**Ward Committee Scheme 06/07
Report to Fishergate Ward Committee**

Your Reference:- FS- Our Reference:- 0609904 Date:- 31st July 2006
06-01

Broadway Shops – Parking and Pedestrian Access

Appendix 1

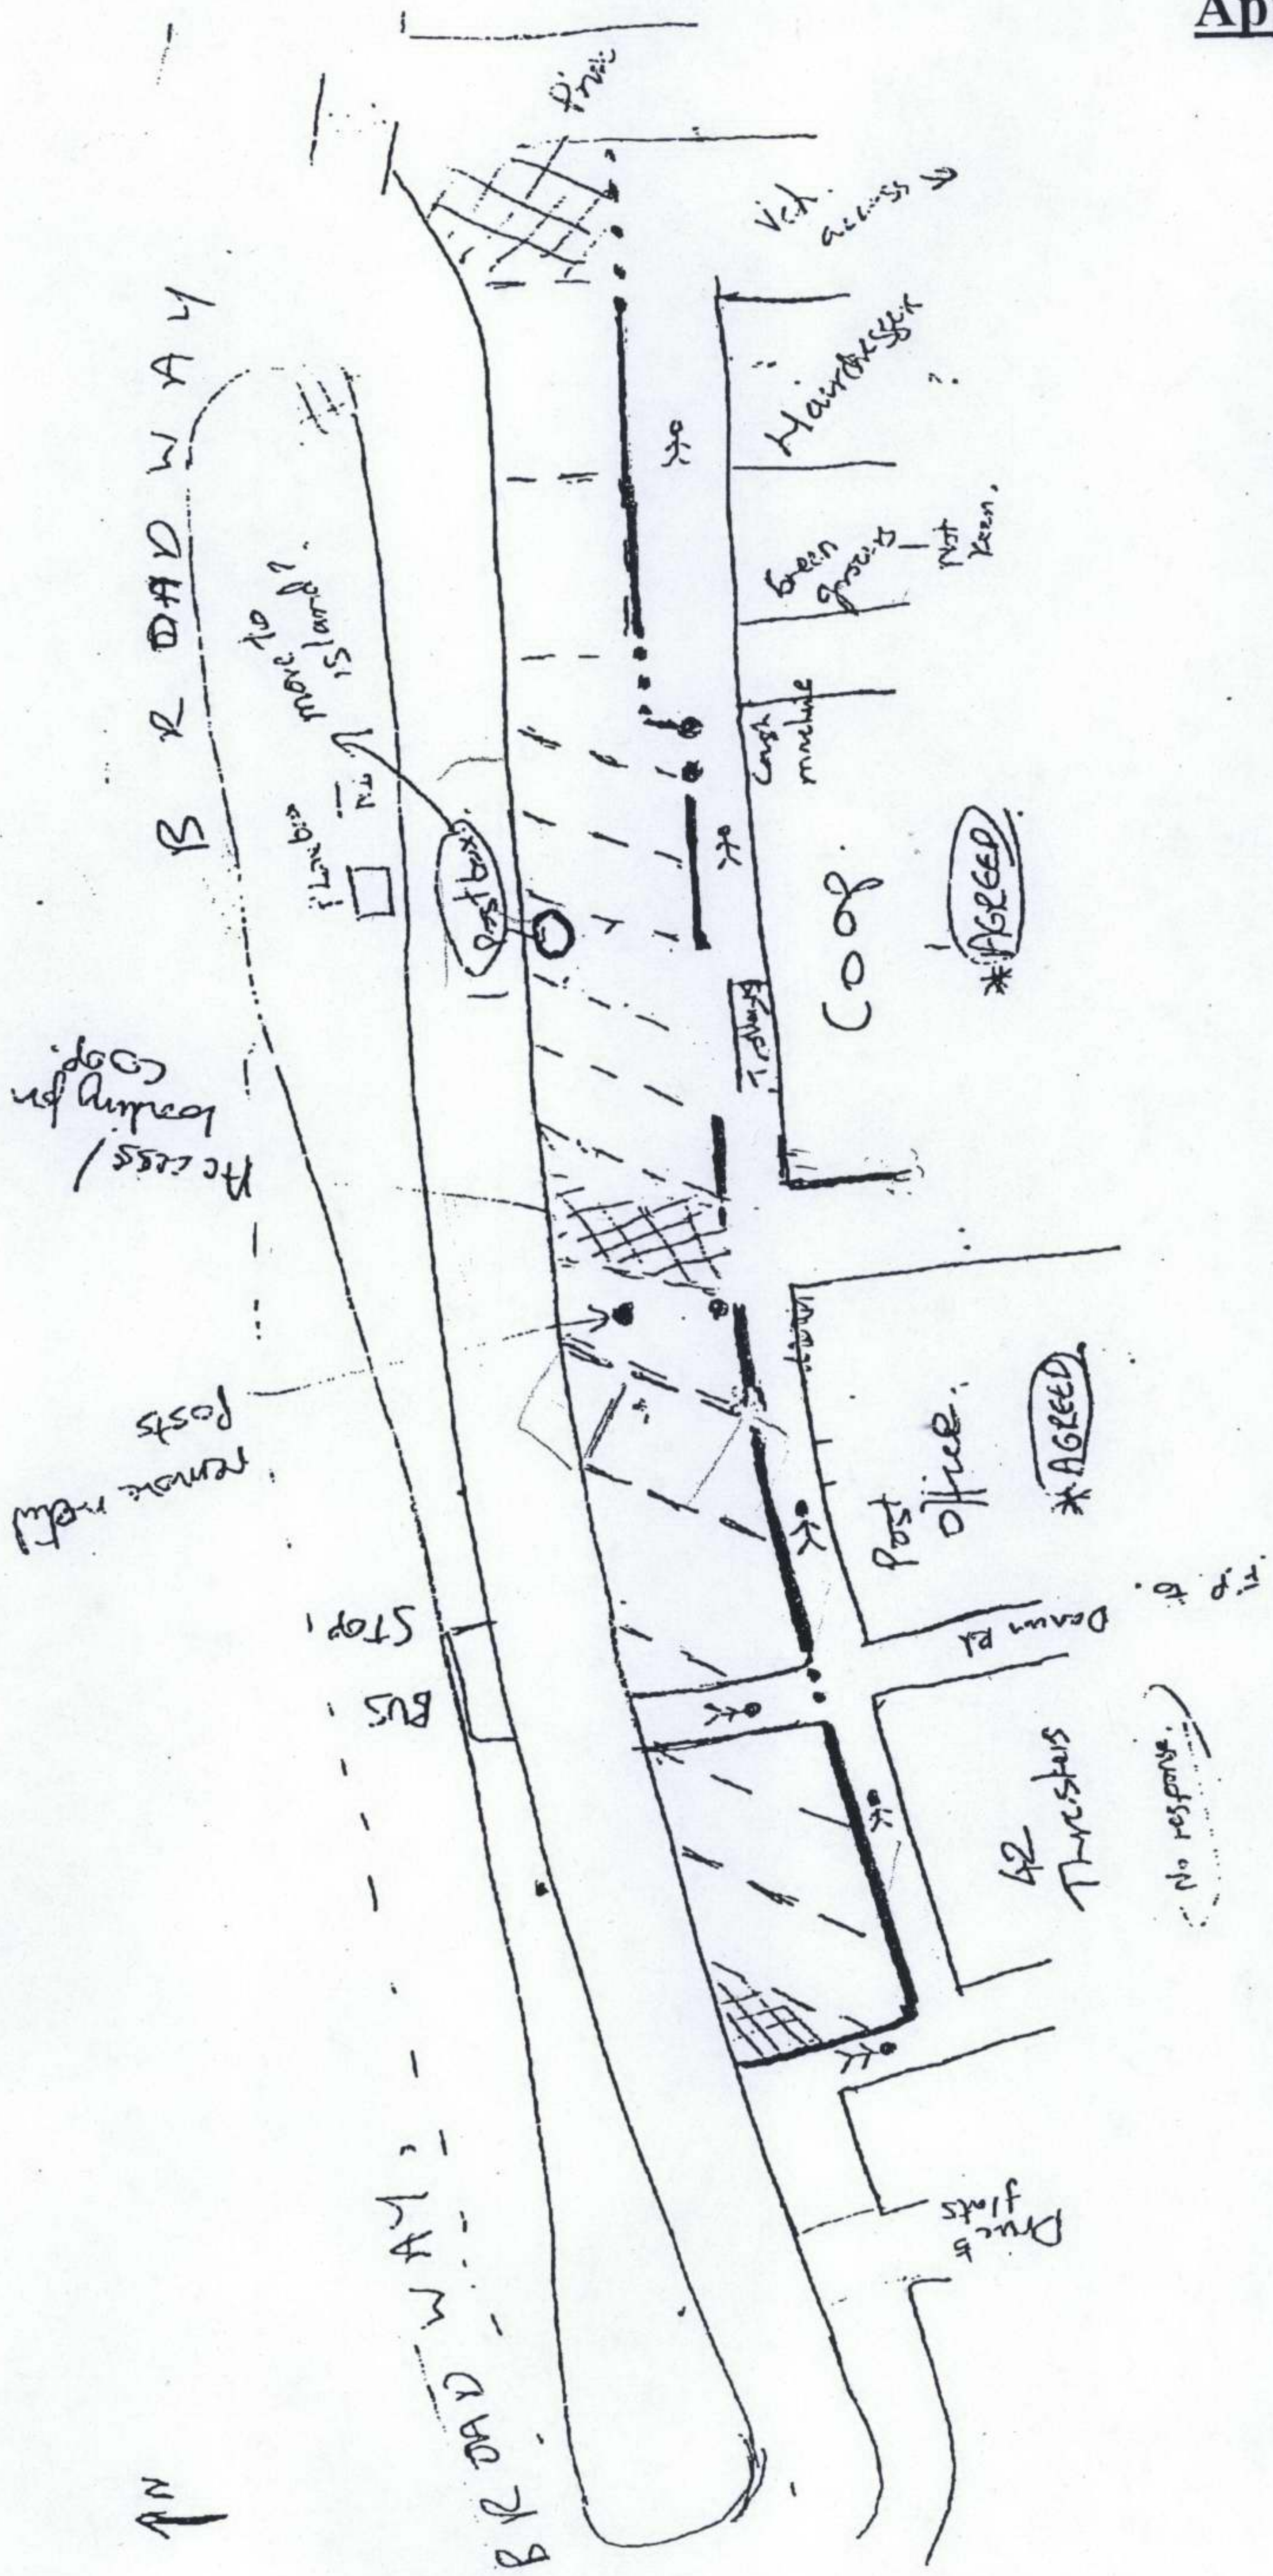
- 4.1 As a result of the problems being experienced by pedestrians at the site, a suggestion has been made to create a more systematic layout for parking and pedestrian areas at this location.
- 4.2 The suggested arrangement is shown on the attached sketch at Appendix 1 (Councillor D'Agorne's sketch) which is an attempt to create an echelon parking area for vehicles and defined areas for pedestrians.
- 4.3 The feasibility of creating a layout based on this suggestion has been investigated, including an assessment of options for arranging parking bays at various angles to the access road. Unfortunately, none of these options appears to offer a practicable solution, as explained below.

4.4 As a general comment, all options which involve 90-degree or echelon parking necessarily require vehicles reversing on the forecourt out of the spaces into the service road, with associated problems for pedestrians (who may be unfamiliar with echelon parking layouts) crossing from the central island. There may also be the need for physical barriers to prevent echelon-parked vehicles overhanging or encroaching on pedestrian areas of the forecourt.

- The average width of the forecourt has been measured as 6.10m. Allowing 1.80m for a minimum width of pedestrian provision adjacent to the shop fronts, this leaves approximately 4.30m to accommodate the vehicular parking provision. However, the standard length of a parking bay is 4.80m, which is the distance needed to accommodate most cars and small vans. Hence there is insufficient forecourt space to accommodate 90-degree parking bays if 1.80m were reserved for pedestrian provision.

- Also, to enable vehicles to manoeuvre squarely into a 90-degree parking bay, a manoeuvring width of 6.00m is required. At present, the access road from which vehicles would be manoeuvring is 3.10m. This means vehicles could not manoeuvre into the parking spaces without running up on to central island, or entering the bays at an angle. The attached plan no. TS/WC/FS-01-06/0609904/002 illustrates the 90-degree situation on site, together with the swept paths necessary to access the parking bays squarely.

- Given the constraints of the narrowness of the access road, the drawing shows that this is not practicable without having very wide parking bays. Even then, vehicles have got to park at an angle which tends towards an echelon parking arrangement. Furthermore, to accommodate right-angled bays, and to prevent them overhanging the narrow access road, the footway width adjacent to the shops would have to be reduced to 1.30metres. A footway of this width would not be able to accommodate two wheelchairs or two pushchairs passing one another. The footway width would also be further reduced outside the Co-op, as there are bollards protecting the cash machine, and an area for shopping trolley storage.

- The combination of the limited depth of the forecourt area and the lack of manoeuvring width in the access lane mean that 90-degree parking is not a feasible option for this location.

- Inclining the parking bays at a 60-degree angle reduces the manoeuvring width required to turn squarely into the parking bay to 4.20m. This still exceeds the available width of the access road of 3.10m, which means that the parking bays would have to be made wider than normal to enable cars to access them.
- However, a more fundamental problem is that the inclined length of the parking bays (top corner to bottom corner dimension of the bay) increases the effective space requirement

on the forecourt to 5.40m, which, again, significantly exceeds the 4.30m available. This means that the end of larger cars would still stick out and obstruct the access road.

- The combination of the limited width of the forecourt area and the lack of manoeuvring width in the access lane mean that 60-degree parking is not a feasible option for this location.

- Inclining the parking bays at a 45-degree angle reduces the manoeuvring width to turn squarely into the parking bay to 3.60m. This still exceeds the available width of the access road of 3.10m and means that wider than normal bays would be needed. The attached plan no. TS/WC/FS-01-06/0609904/003 illustrates the 45-degree situation on site, together with the swept paths necessary to access the parking bays. The inclined length of the parking bays, however, increases the space requirement on the forecourt to 5.10m, which, again, significantly exceeds the 4.30m available. This means that vehicles would stick out into the access road if the required 1.80m footway is to be achieved.
- The combination of the limited width of the forecourt area and the lack of manoeuvring width in the access lane mean that 45-degree parking is not a feasible option for this location.

- By reducing the angle of the echelon parking further, say to 30 degrees or less, it may be feasible to accommodate some degree of echelon parking. However, the capacity benefits over simply parking parallel to the road are minimal, and the drawbacks of echelon parking still remain (principally that vehicles are constrained to reverse out into the access road, with poor rearward visibility and the associated difficulties for pedestrians crossing from the central island). With parallel parking, the layout is well known and well understood by motorists and pedestrians alike, and vehicles can drive in and out of the parking bay area in forward gear, and servicing to the shops could be accomplished from the parking bay.

- 5.1 The favoured option to provide more adequately defined pedestrian areas and clearly defined customer parking is shown on drg. no. TS/WC/FS-01-06/0609904/004. This option, as explained above will provide a 2.40m wide parking lay-by immediately adjacent to the existing service road.

- 5.2 The reduced width of forecourt of 3.70m will comfortably accommodate a pedestrian route of 1.80m minimum width, leaving 1.90m width to accommodate shop owners' merchandise and a relocated post box.

- 5.4 Currently, the service road is two-way. With a road of restricted width of 3.10m, this is undesirable, and it is suggested that, if the improvement scheme is approved and proceeds, a

Traffic Regulation Order (TRO) is implemented to convert this service road into a one-way route, permitting traffic to proceed along it in a westerly direction only.
